Subject: DRIVER-SIDE POWER DOOR MIRROR VIBRATION	Bulletin No: 09-032/15
	Last Issued: 08/12/2015

- This bulletin supersedes the previous bulletin 09-026/14 issued 06/10/14 and 09-002/13 issued 02/26/13, 10/24/13. The REPAIR PROCEDURE, PART(S) and WARRANTY INFORMATION have been revised.
- Changes are noted below in Red beside the change bar.

2013-2015 CX-5 vehicles with VINs lower than JM3KE*****465579 (produced before April 1, 2014)

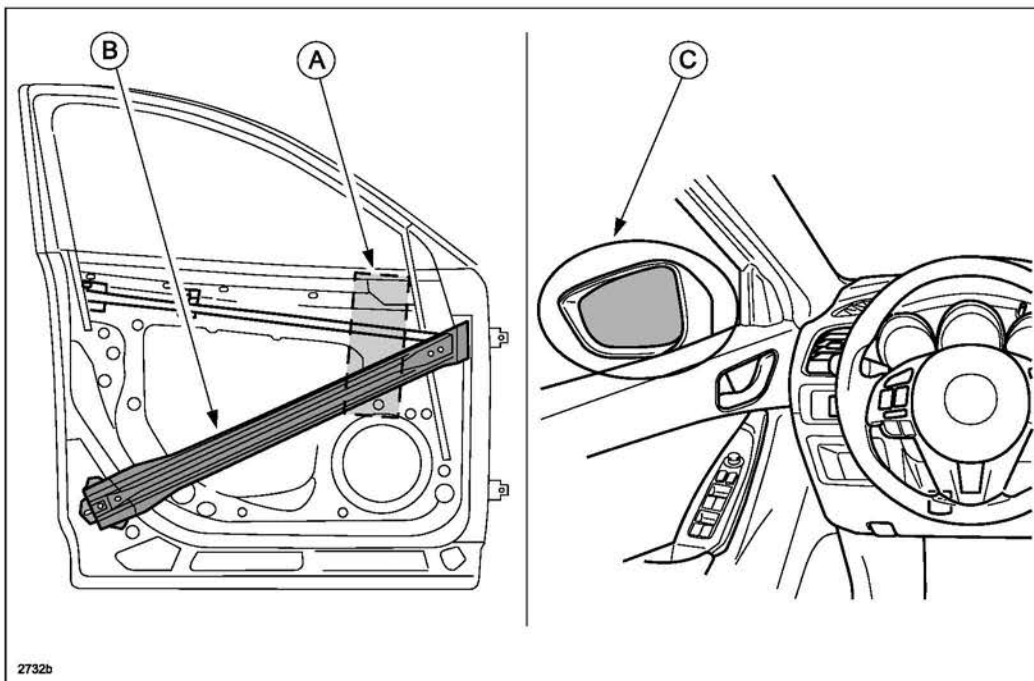
An additional reinforcement has been installed inside the door to increase the door panel strength where the door mirror is mounted. Also, the door mirror shape has been changed. Both of these modifications have been implemented to eliminate mirror glass vibration concerns.

Repair A	Repair B
Install a new upper reinforcement (A) onto the side impact bar-lower (B) in the driver's side door to increase the rigidity of the door panel where the power door mirror is located.	<p>Replace both side door mirrors (C) with modified (mass-production) parts according to MS3 online or the Workshop Manual.</p> <p>NOTE: Since the shape of the modified (mass-production) mirror is different than the previous mirror, it is necessary to replace both side mirrors so they match.</p>

REPAIR A:

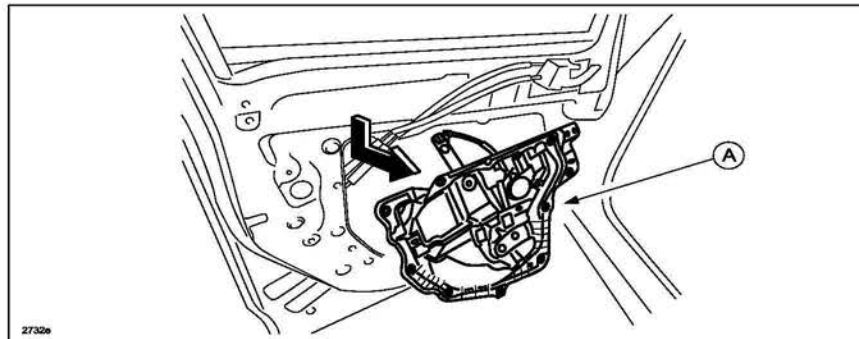
1. Remove the driver's side power door mirror according to the instructions on MS3 online or the Workshop Manual (section 09-12 POWER OUTER MIRROR REMOVAL/INSTALLATION).
2. Remove the driver's side door panel according to the instructions on MS3 online or the Workshop Manual (section 09-11 FRONT DOOR MODULE PANEL REMOVAL/INSTALLATION).
3. Remove the front door module panel (A) according to the instructions on MS3 online or the Workshop Manual (section 09-11 FRONT DOOR MODULE PANEL REMOVAL/INSTALLATION).

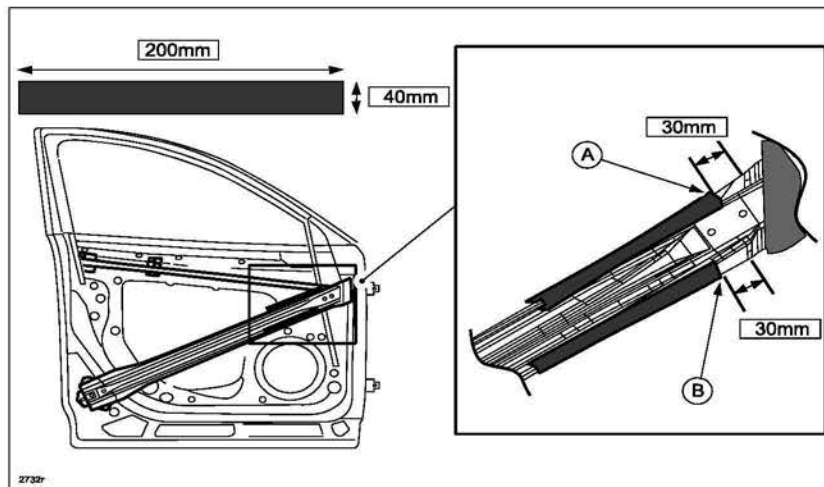
4. For rust prevention, attach two (2) self-stick pads (200mm x 40mm) to each edge of the side impact bar-lower (as shown below) where the bracket and reinforcement are installed.

<cross-section>

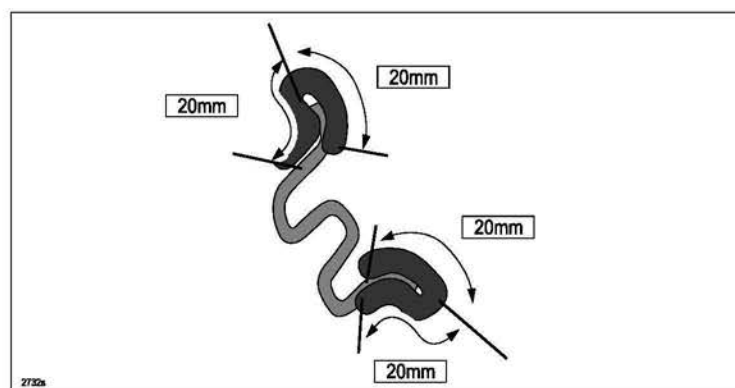
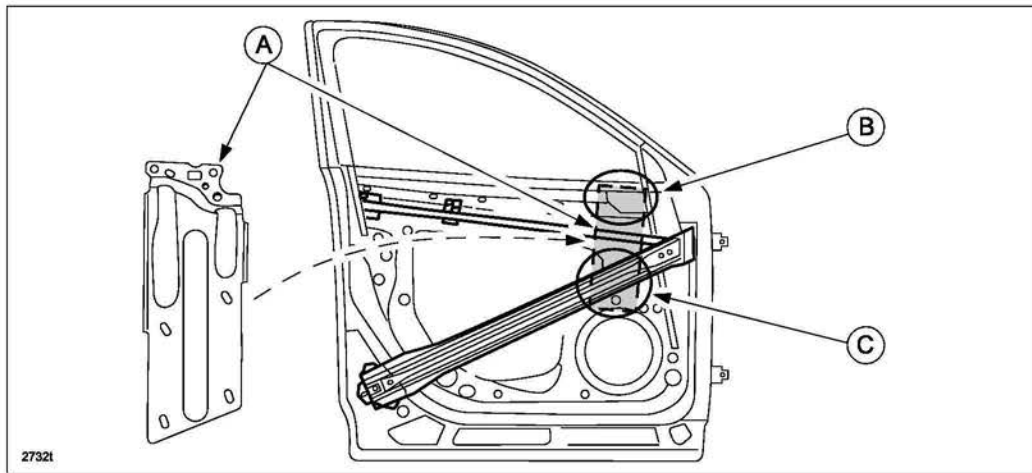
NOTE: Attach the pads starting from the position indicated below at locations (A) and (B).

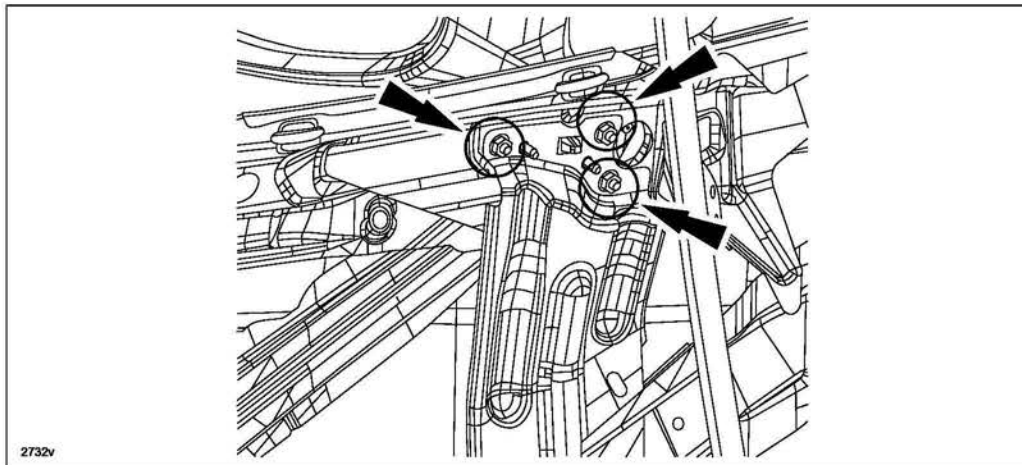
5. Install the reinforcement (A) as shown below. Secure the upper part (B) together with the power door mirror and the lower part (C) to the side impact bar-lower with the two (2) brackets.

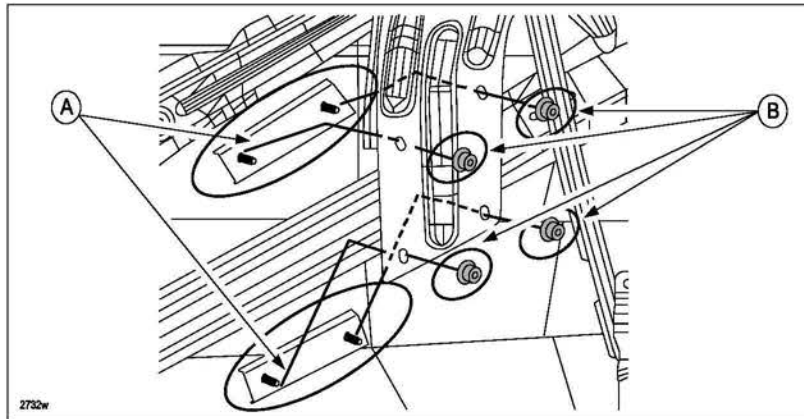
6. While holding the power door mirror, temporarily place the reinforcement with the three (3) power door mirror bolts through the holes in the reinforcement, then tighten the bolts.
Tightening Torque: 11 ft. lbf. {1.5 kgf-m, 15 Nm}

- Place the two (2) brackets (A) (upper and lower) in the back of the reinforcement and pass the stud bolts through the holes in the reinforcement.

NOTE: Pinch the flange of the side impact bar-lower with the bracket and the reinforcement.

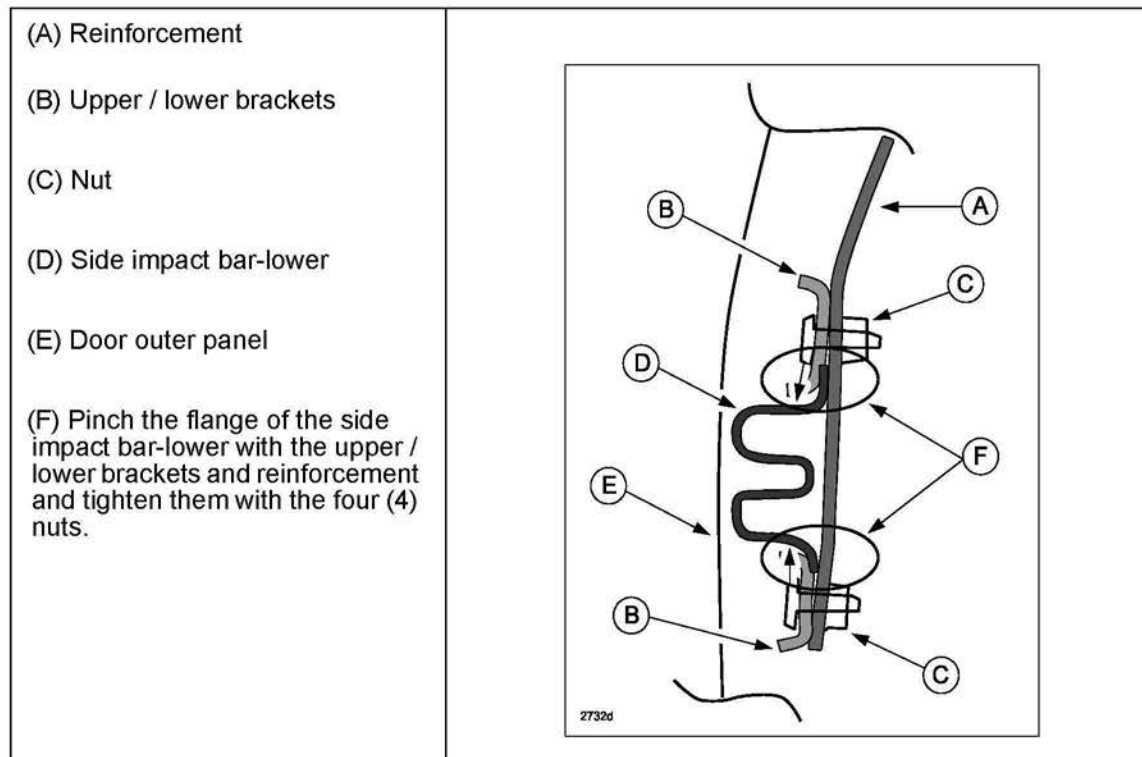
- Tighten the four (4) nuts (B) to secure the reinforcement onto the side impact bar-lower.
Tightening Torque: 15 ft. lbf. {2.1 kgf-m, 20 Nm}

- Tighten the brackets so that the side impact bar-lower is pushed toward the direction of the arrow.
- Ensure that each part does not touch petal to petal face or it will cause rust occurrence.

REPAIR B:

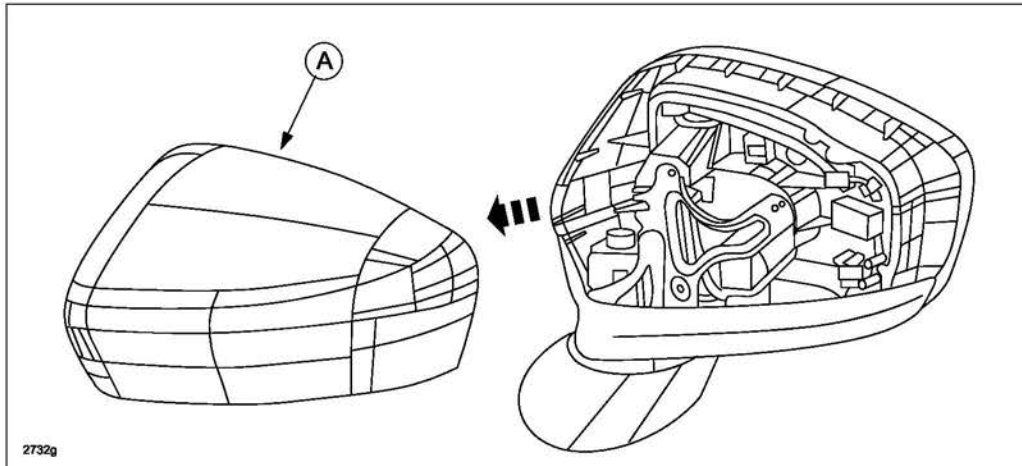
1. Remove both power door mirrors (A) according to the instructions on MS3 online or the Workshop Manual (section 09-12 POWER OUTER MIRROR REMOVAL/INSTALLATION).
2. **Install a new garnish (mirror housing) (A) onto both new door mirrors** according to the instructions on MS3 online or the Workshop Manual (section 09-12 OUTER MIRROR GARNISH REMOVAL/INSTALLATION).

3. **Install new door mirrors** according to the instructions on MS3 online or the Workshop Manual.
4. **Verify the repair.**
